Access Compliance Report Public Rights-of-Way (Curb Ramps)

Intersection ID: 11232 Main Street: BARRINGTON_DR Cross Street: MILTON_RD Location: NW

ADA ID: 0056BF29E90B Ramp Type: PerpDiag Initial Pass/Fail: Fail Overall Compliance: No Severity Score: 33.75

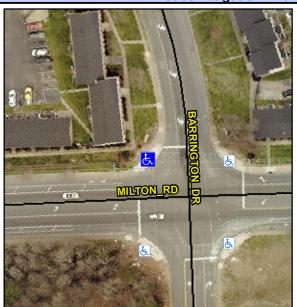
Not Found, R304.5.1, R304.2.2

Field Measurements/Component Compliance					
Compliance Description		Data	Comp	liance Description	Data
N/A	Ramp Length (in)	60.0	No	Ramp Slope (%)	14.7
No	Ramp Width (in)	41.0	Yes	Ramp XSlope (%)	1.1
N/A	Flare Type LT	N/A	N/A	Flare Type RT	N/A
N/A	Flare Slope LT (%)	N/A	N/A	Flare Slope RT (%)	N/A
N/A	Flare Traversable LT?	N/A	N/A	Flare Traversable RT?	N/A
N/A	Landing Length (in)	N/A	N/A	DWS Provided?	N/A
N/A	Landing Width (in)	N/A	N/A	DWS Contrast?	N/A
N/A	Landing Slope (%)	N/A	N/A	DWS Length (in)	N/A
N/A	Landing X Slope (%)	N/A	N/A	DWS Full Width?	N/A
N/A	Landing Curb? (Y/N)	N/A	N/A	DWS Offset (in)	N/A
N/A	Shared Landing?	N/A			
N/A	Gutter Ponding?	N/A	N/A	Gutter Slope (%)	N/A
N/A	Gutter Lip Ht (in)	0.5	N/A	Gutter X Slope (%)	N/A
N/A	Painted X Walk1?	No	N/A	Painted X Walk2?	No
	X Walk 1 Direction	To S		X Walk 2 Direction	To E
N/A	X Walk 1 Width (in)	N/A	N/A	X Walk 2 Width (in)	N/A
	X Walk 1 Slope (%)	0.4		X Walk 2 Slope (%)	2.5

Remove & Replace Curb Ramp With
Two New Directional Ramps or
Equivalent.
